1. **5065 and 5085 Main Street:** Applicants, K&K Developers, Inc., Trumbull Shopping Center #2, LLC and WEA CT Houses LLC are requesting a Special Permit with a site plan to allow a proposed 260 unit multi-family residential community and associated site improvements pursuant to Art. II, Sec. 3.4, of the Town of Trumbull Zoning Regulations. **File #20-04** (*Continued from PZC July 15, 2020 Special Meeting and August 19, 2020 Regular Meeting).*

K&K Developers, Inc., Trumbull Shopping Center #2, LLC and WEA CT Houses LLC
Responses to P&Z Commission's Questions
July 15, 2020 Public Hearing

The Applicants are pleased to offer the following responses to the questions posed by the members of the Trumbull Planning & Zoning Commission during the July 15, 2020 portion of the public hearing. The Applicants' response is set forth immediately after each question.

ILLUSTRATIVE SITE ELEVATION PEDESTRIAN CONNECTION TO RING ROAD & MALL

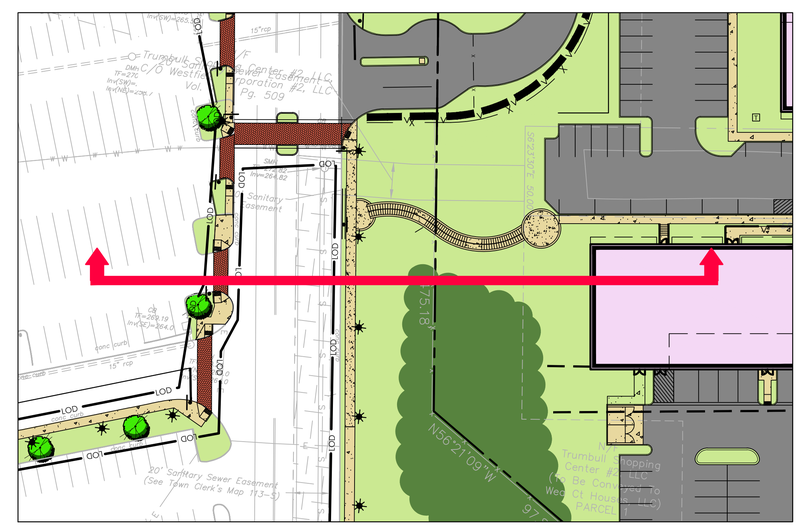
Q: On the E/W road, how does one get from the community to the mall?
A: The internal road heading west toward the mall terminates at the edge of the slope. Drivers seeking to travel to the mall will turn right (heading north) and access the proposed driveway connection that leads to the ring road. Pedestrians will travel down the proposed staircase leading to the crosswalk across the ring road.

Q: Will sidewalks be provided for entire length?
A: Yes. Sidewalks are provided throughout the community as a "town center" type community. The sidewalk system links to the staircase leading the ring road crosswalk. The plans have also been revised to include an accessible sidewalk from the Residences to the ring road crosswalk. In addition, a walking path has been added on the inside of the stone walls along Main Street, which is also depicted on the revised site plans.

Title
PEDESTRIAN CIRCULATION PLAN

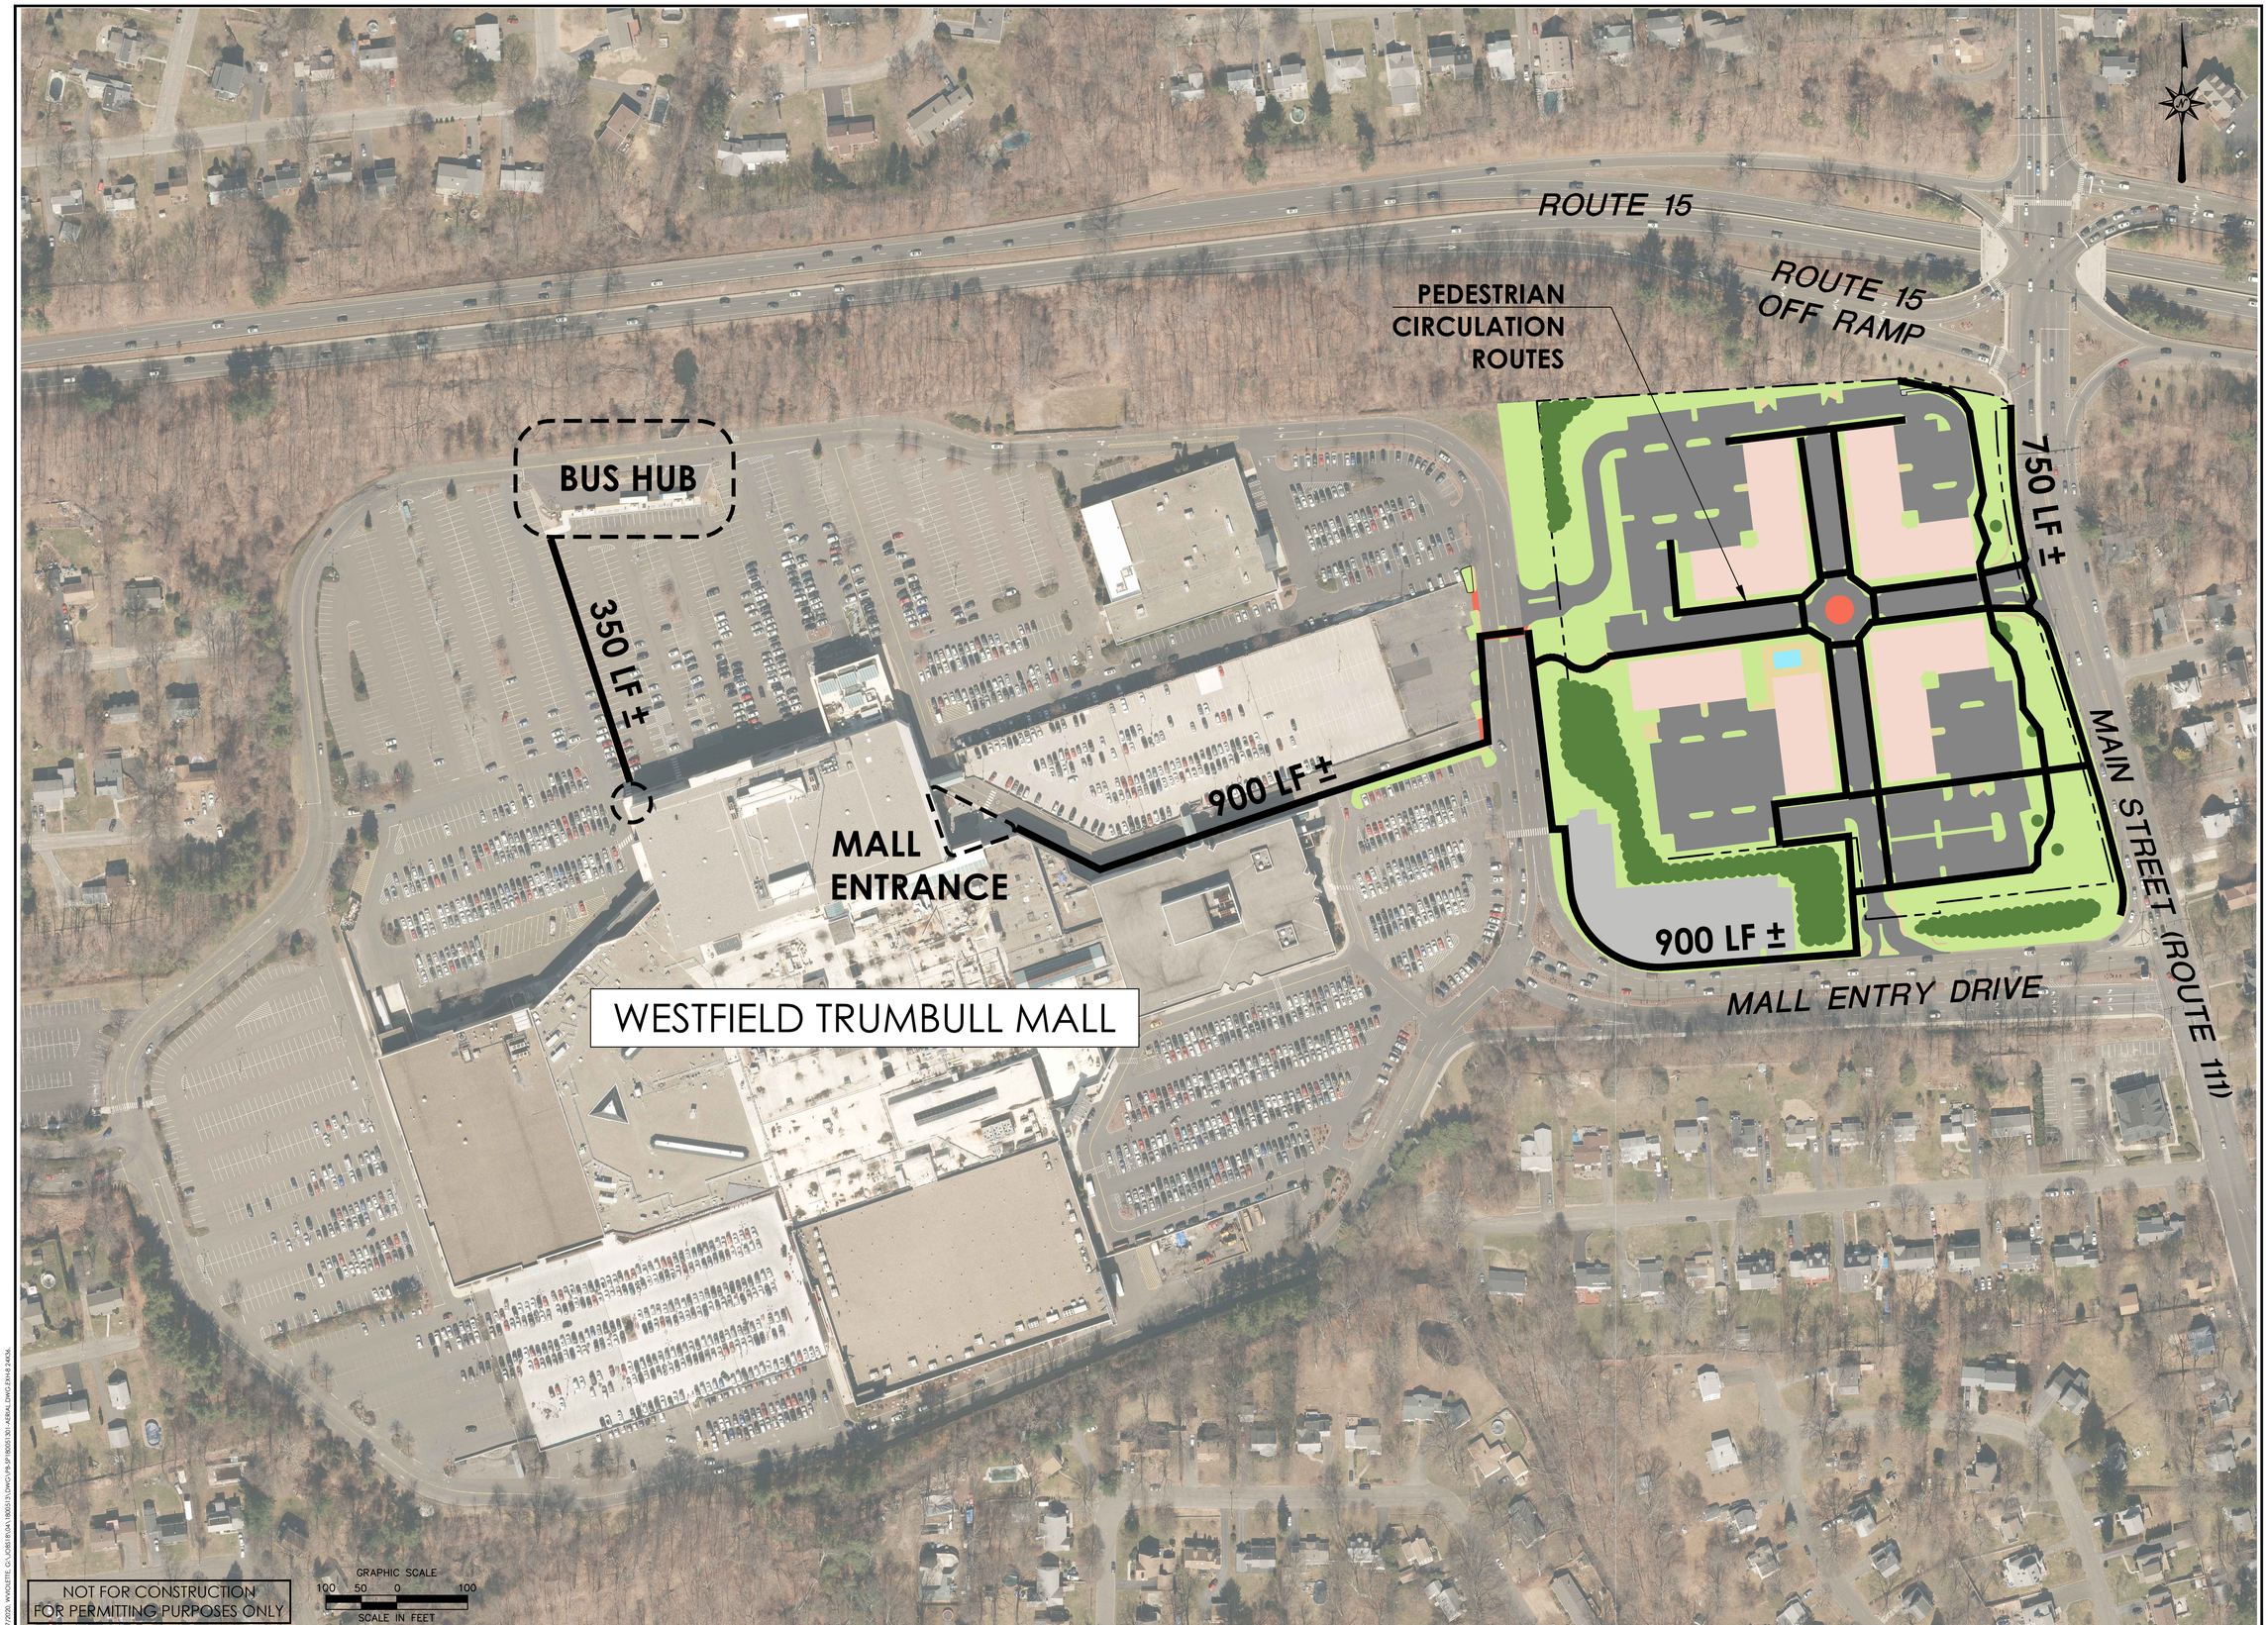
Q: How can we improve walkability? Many residents will likely want the opportunity to take a walk, particularly in the evening.
A: In addition to the ability to walk throughout the community, down to the mall, and in the residential areas to the north and the east, the applicants have submitted a revised landscape plan that depicts a walking path along the interior of the stone walls adjacent to Main Street that connects to the overall sidewalk plan.

VIEW OF PEDESTRIAN IMPROVEMENTS AT MALL RING ROAD

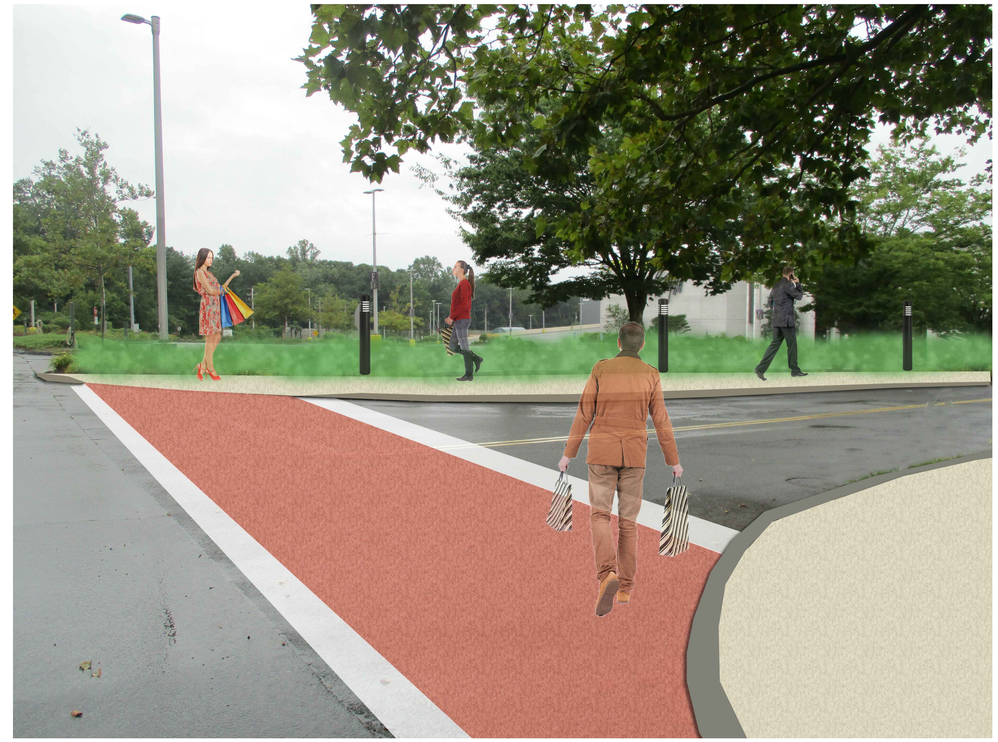
Q: How safe is it for pedestrians to cross the ring road? Is it sufficient with just flashers? Is anything else needed?
A: The applicants and their professionals are fully confident that the proposed crosswalk will be safe for pedestrians. A new cross-section and other materials have been provided with this memo to better depict the variety of features that are proposed to ensure pedestrians' safety. The crosswalk has been revised to provide a median refuge area to decrease the crossing distance across the ring road. The crosswalk area includes high-visibility paint and rectangular rapid flashing beacons with advanced warning signage. These elements are proven safety countermeasures by the Federal Highway Administration.
